Field Installation Instruction

Rewiring the Motor Control TAC signal

DOC NBR: TEC-303A

Rewiring the TAC signal through the Isolation Board

Figure 1. Before Rewire (Rev 2)

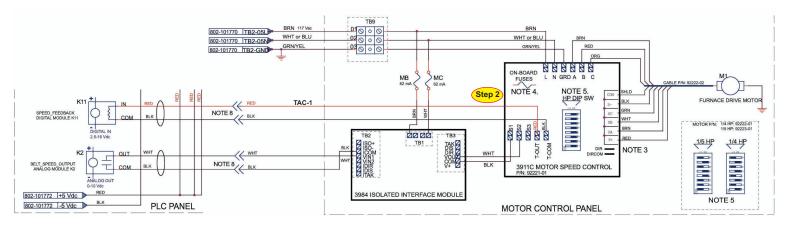
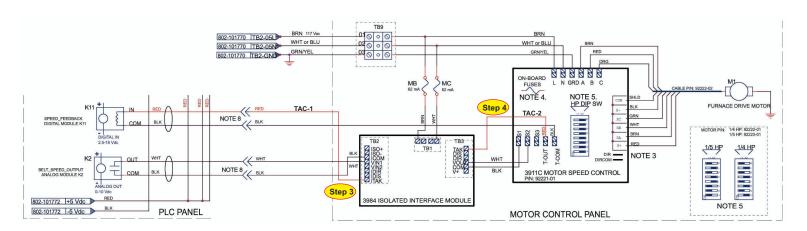
- 1. Make sure furnace power is off.
- 2. Disconnect red TAC-1 wire at T-OUT terminal on 3911C Motor Speed Control board (figure 1).
- 3. Connect red TAC-1 wire to TB2-ITAK terminal on 3984 Isolated Interface module (figure 2).
- 4. Connect a new red TAC-2 wire from TB3-TAK on 3984 Isolated Interface module to T-OUT on 3911C Motor Speed Control board (figure 2).
- 5. Follow instructions on TEC-303 to adjust pots, start furnace. Calibrate belt speed.
